The Drovers Solar Farm

Consultation Report Appendix I: Targeted Consultation Overview and Supporting Materials

Document reference: APP/5.2

Change 1 – Additional land to accommodate Skylark and Curlew mitigation

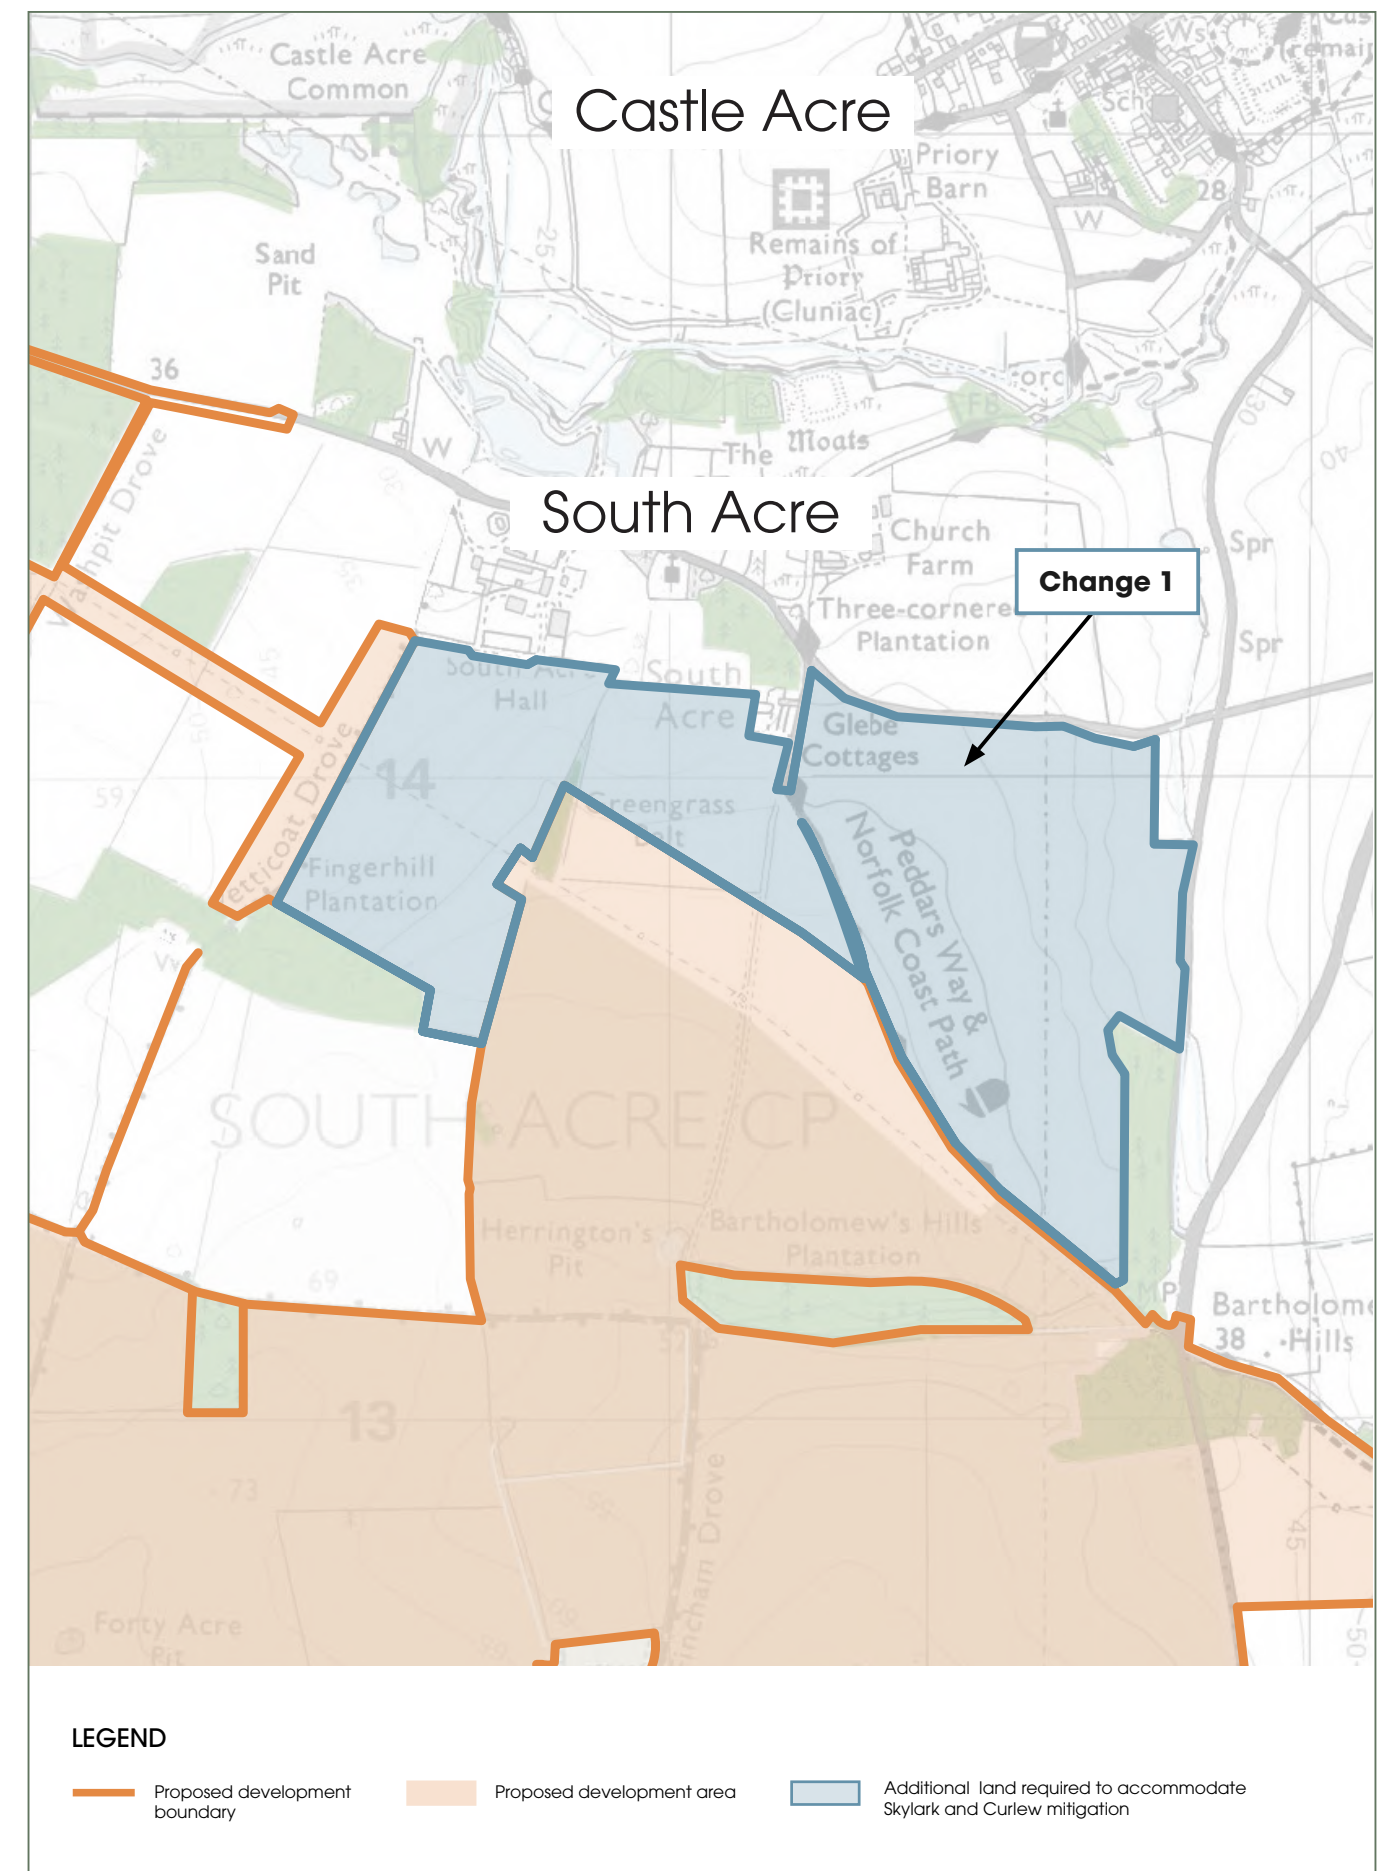
Change 1 - Additional land to accommodate Skylark and Curlew mitigation Aerodromes and aviation	<p>Birdstrike safeguarding zone</p> <p>The proposed development is within the statutory birdstrike safeguarding zone surrounding RAF Marham. Within this zone, the principal concern of the MOD is the creation of landscape features such as open bodies of water, wetland habitat or other forms of habitat creation and landscaping may attract and support populations of large and, or flocking birds hazardous to air traffic. The inclusion of these features in the proposed development could contribute to an increase in birdstrike risk to air traffic operating from RAF Marham. The mitigation proposal for Skylark and Curlew includes land designated and managed to create and allow suitable conditions for Curlew. At present no details are available of how this will look. These fields will be suitably sized to allow offset from the field boundaries, and the land will be managed throughout the life of the project with an outline environmental management plan to be submitted at a later stage. The creation of habitat targeted at Curlew usually includes management as a hay meadow or by grazing, with vegetation of varied heights and with vegetation typical of damp habitats favoured. The inclusion of damp areas should not result in a significant attractant for hazardous birds in this location; however, the inclusion of shallow pools has the potential to create environment that may attract and support populations of large and, or flocking birds hazardous to air traffic.</p>	No	<p>The Applicant notes this and confirms that engagement with the Defence Infrastructure Organisation regarding safety zones is ongoing.</p> <p>The Applicant does not consider there to be an increased risk in terms of attracting hazardous bird species, as the proposed mitigation is for Skylark, Lapwing, and Curlew would not include the creation of shallow pools.</p> <p>Appendix 7.3: Proposed Mitigation Strategy for Ground Nesting Birds Requiring Open Habitats [APP/6.4] provides further detail regarding proposed mitigation and compensation package in relation to ground-nesting bird species. Measures will include the following:</p> <ul style="list-style-type: none"> • Provision of new managed open grassland areas providing specific opportunities for ground nesting species • Favourable management of grassland margins and associated habitats, which will provide increased foraging value and therefore raise carrying capacity across the site as a whole for these species; and • Incorporation of Skylark plots within arable land located outside of the solar development areas.

Change 1 - Additional land to accommodate Skylark and Curlew mitigation Aerodromes and aviation	The MOD advises the design of any habitat creation, drainage basins, landscaping and planting that may be included in the development, should be undertaken to minimise the attractants that are afforded to bird species considered hazardous to aviation in proximity to RAF Marham. The above concerns will need to be addressed in the preparation of any application relating to this proposal and the MOD should be consulted, via the above multiuser email address at all future application stages of this development to allow further detailed safeguarding assessments to be completed.	No	<p>The Applicant does not consider there to be an increased risk in terms of attracting hazardous bird species as a result of the proposed mitigation.</p> <p>The Applicant is, however, open to further discussion with the DIO regarding the matter.</p>

Update 1 – Refinement of BESS and substation locations

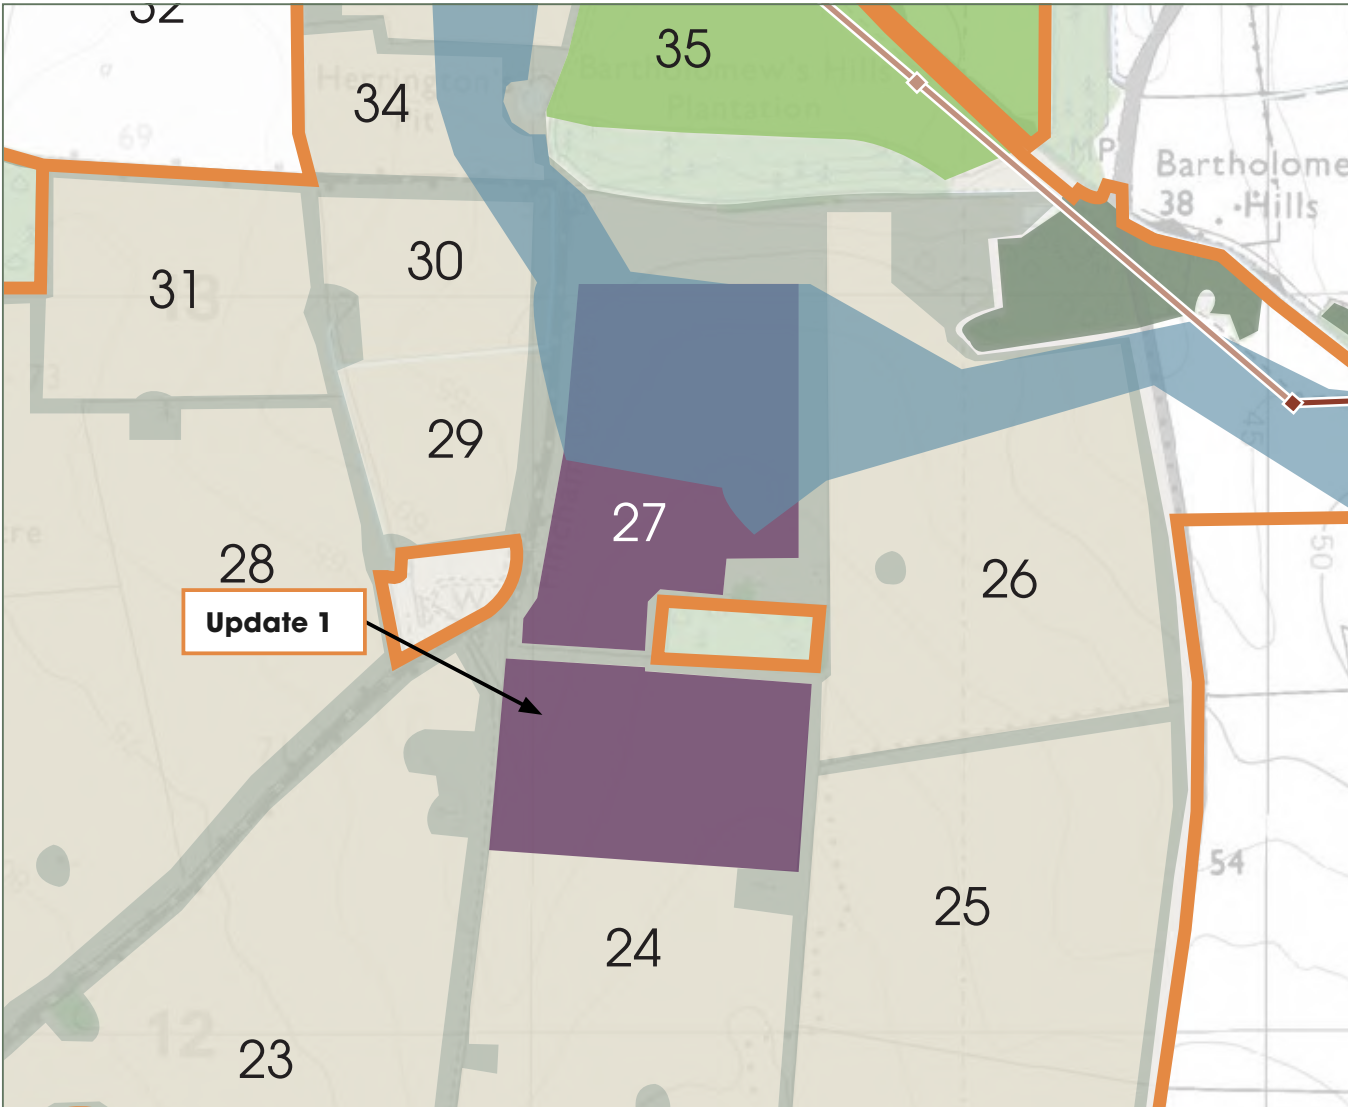
Update 1 - Refinement of BESS and substation locations	It should be noted that whilst the BESS and Substations will be screened by Bartholomew's Hill Plantation, this screening is reliant upon the plantation trees. As such, visibility could change in the future as the plantation is managed. As mitigation is reliant upon the plantation the Council would expect a management plan to be put in place for the lifetime of the development to ensure that the appropriate level of screening is maintained.	No	The Applicant thanks the Borough Council of King's Lynn and West Norfolk for its feedback on the updates provided. The Applicant confirms these updates were shared as part of ongoing community engagement, but were not subject to targeted consultation; as such, a detailed response has not been provided. Responses to matters raised during the statutory consultation are set out in Consultation Report Appendix G: Section 42 – Responses Received and Applicant's Responses [APP/5.2] and Consultation Report Appendix H: Section 47 – Responses Received and Applicant's Responses [APP/5.2] . The Applicant considers that feedback on the Scheme has been adequately addressed through those responses.

Update 1 - Refinement of BESS and substation locations	The Conservation Team note that the proposed change has made a difference to the impact of the proposal upon the historic village of Castle Acre. The views out of Castle Acre and the way that the village is experienced in the landscape is now much improved from the first scheme. However, we note that the final arrangement of buildings and heights has yet to be arranged and that the final impact is yet to be assessed. We consider that the scheme has moved in the right direction and should it continue to move along this route, we would be happy to continue to work with the applicant to come up with a final arrangement of buildings that continues to minimise the harm.	No	The Applicant thanks the Borough Council of King's Lynn and West Norfolk for its feedback on the updates provided. The Applicant confirms these updates were shared as part of ongoing community engagement but were not subject to targeted consultation; as such, a detailed response has not been provided. Responses to matters raised during the statutory consultation are set out in Consultation Report Appendix G: Section 42 – Responses Received and Applicant's Responses [APP/5.2] and Consultation Report Appendix H: Section 47 – Responses Received and Applicant's Responses [APP/5.2] . The Applicant considers that feedback on the Scheme has been adequately addressed through those responses.
